**TOWN OF NEWBURGH  
PLANNING BOARD  
TECHNICAL REVIEW COMMENTS**

**PROJECT: HADID CLEARING & GRADING APPLICATION-34 SUSAN DR.**  
**PROJECT NO.: 21-10**  
**PROJECT LOCATION: SECTION 46, BLOCK 5, LOT 21**  
**REVIEW DATE: 28 MAY 2021**  
**MEETING DATE: 3 JUNE 2021**  
**PROJECT REPRESENTATIVE: ENGINEERING & SURVEYING PROPERTIES**

**RE: W.O. # 1592.01  
PB APPLICATION 2021-10  
HADID  
34 SUSAN DRIVE  
COMMENT RESPONSE**

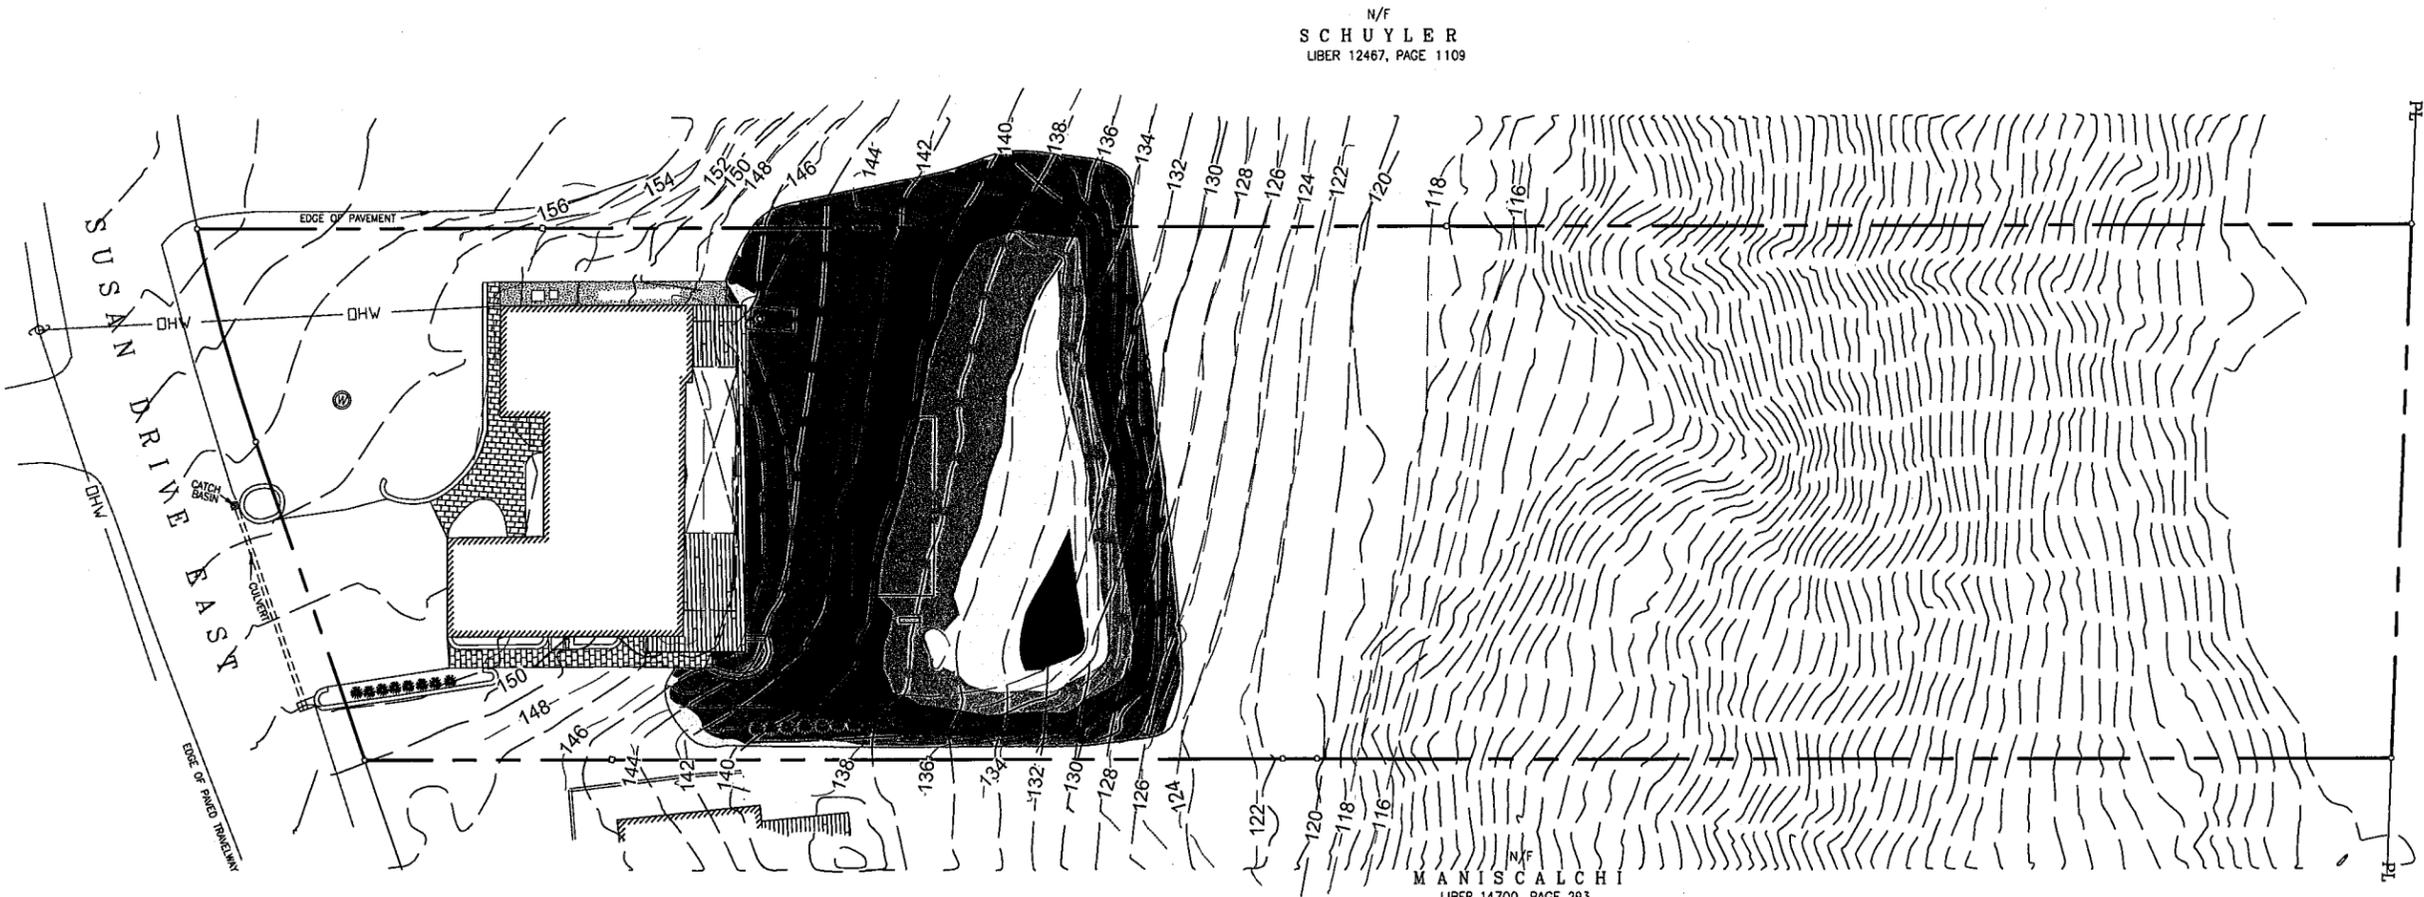
2. The Applicants representative has provided a clearing and grading permit dated 5 January 2021 identifying 1,500 cubic yards of fill to be placed on the site. In the recent submission the Applicant representative has submitted a schematic computer model identifying 2,345 cubic yards of fill on the site. It is noted the computer model uses a 3 foot contour interval to evaluate the amount of material placed.

9. A cut / fill figure (Sheet F-1) has been prepared which compares the contour data provided by Steven P. Drabick P.L.S. (which has been raised 2 feet to approximate the North American Vertical datum of 1988) and USGS 1M hydro-flattened digital elevation models (DEMS) as derived from 2012 source lidar. The volume of fill placed on site is approximately 2,345 cubic yards.

**SITE PLAN**

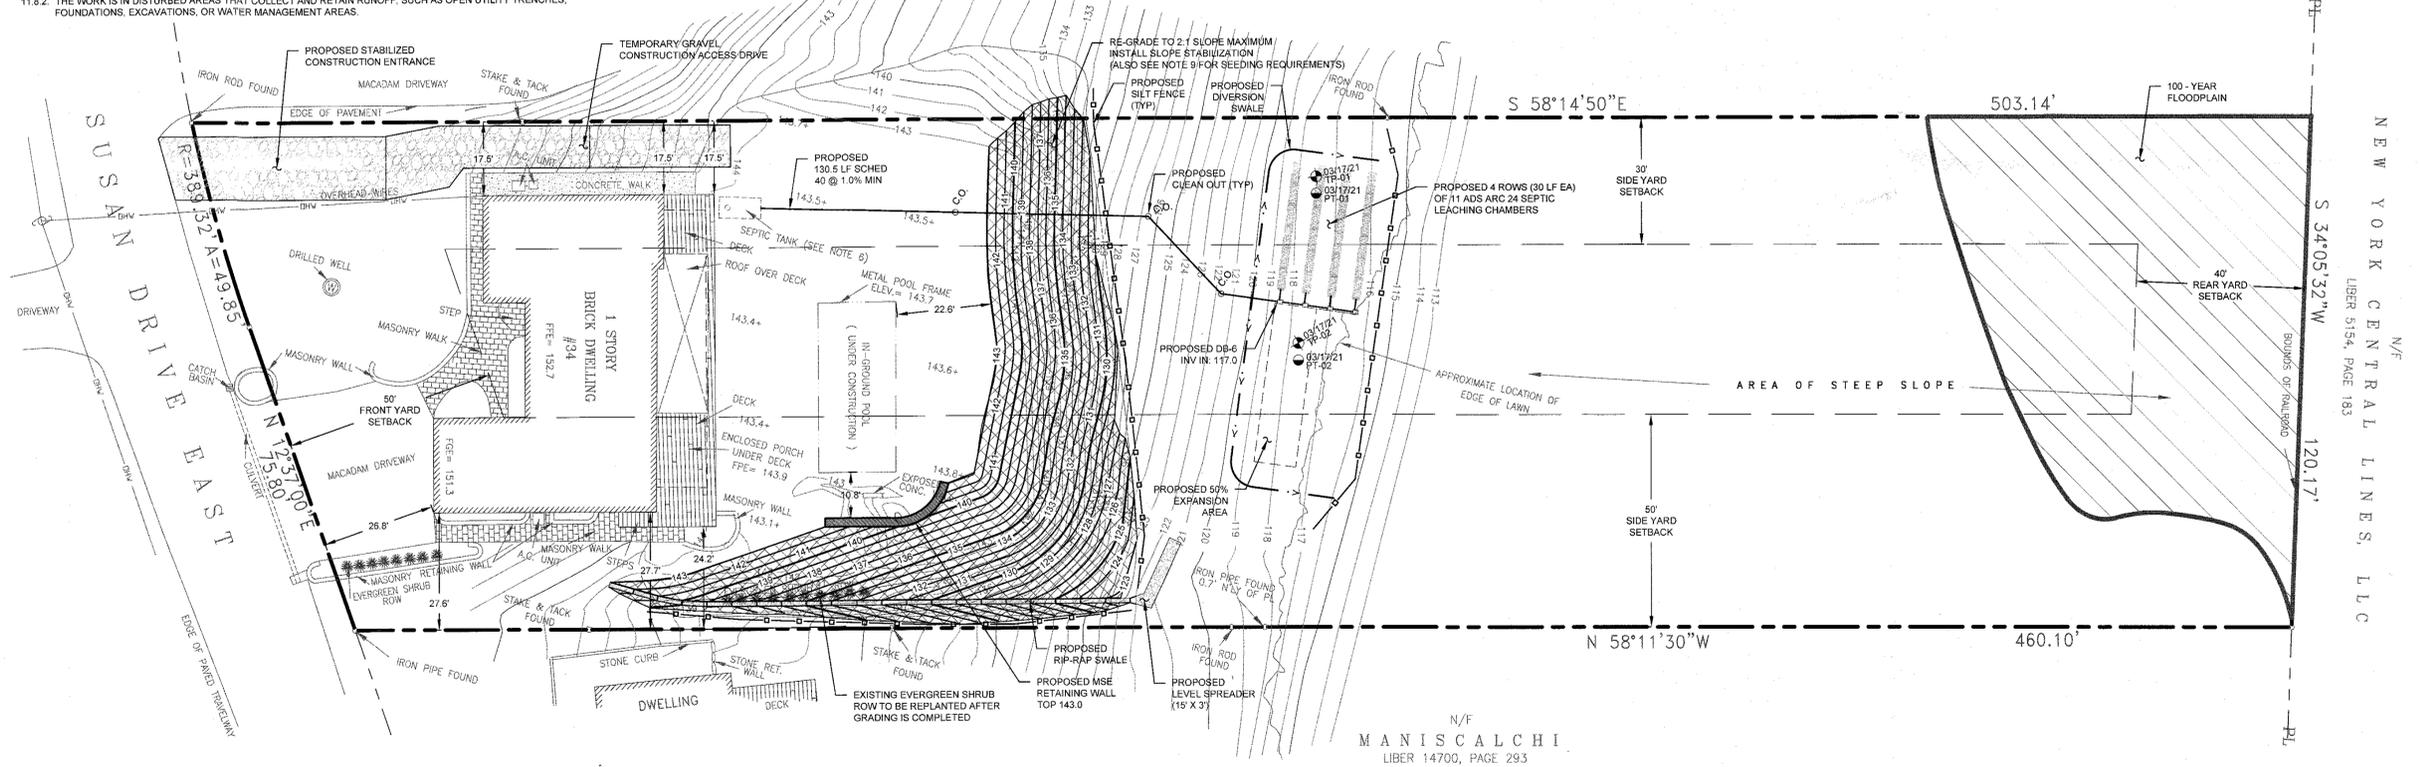
1. The Applicants have provided a revised plan and response comments which proposed modifications to the existing condition. Applicant’s representative’s response to comments fails to identify that the fill material has previously been placed on the residential lot without approvals. The most recent plan submission now proposes substantial grading to the fill on the site.

4. The revised plan identifies a retaining wall proposed in order to reduce the slope on the site. This retaining wall appears to be placed in areas which contain 6-9 feet of fill. Detailed design of this retaining wall should be required in order to assure stability of the wall placed on the un-compacted fill material.

5. Plan continued to depict existing evergreen shrub row to be re-planted after grading. This shrub row is depicted to be planted on a steep slope. Method for planting trees on this slope should be identified.

8. The revised plans seem to identify that fill will now be exported from the site. This should be further evaluated including the loading of the fill material, removal of the fill material from the site, construction access, dust control etc. Volume of the fill proposed to be removed should be identified as part of the clearing and grading permit application.

7. A proposed stabilized construction entrance and temporary gravel construction access drive are shown North of the existing dwelling on Sheet C-1.
8. The Orange County Property Data webpage identifies the existing residence as a "3-bedroom ranch." A copy of the property description has been included as part of this submission.

SANITARY SEWER DISPOSAL SYSTEM PROFILE

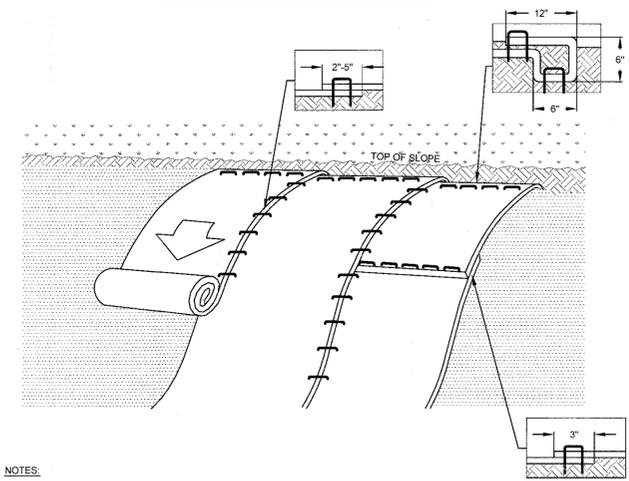
6. The Applicants representative has provided a profile of the proposed sanitary sewer pipe between the septic system and the absorption fields. This profile identifies slopes on proposed pipes of 42% and 19.5%. Velocity within these pipes should be evaluated with regard to impacts on the subsurface sanitary sewer disposal field.

3. A profile of the sanitary sewer disposal system indicating the slope of the pipe between the septic system and the proposed leech field has been provided on Sheet C-2.
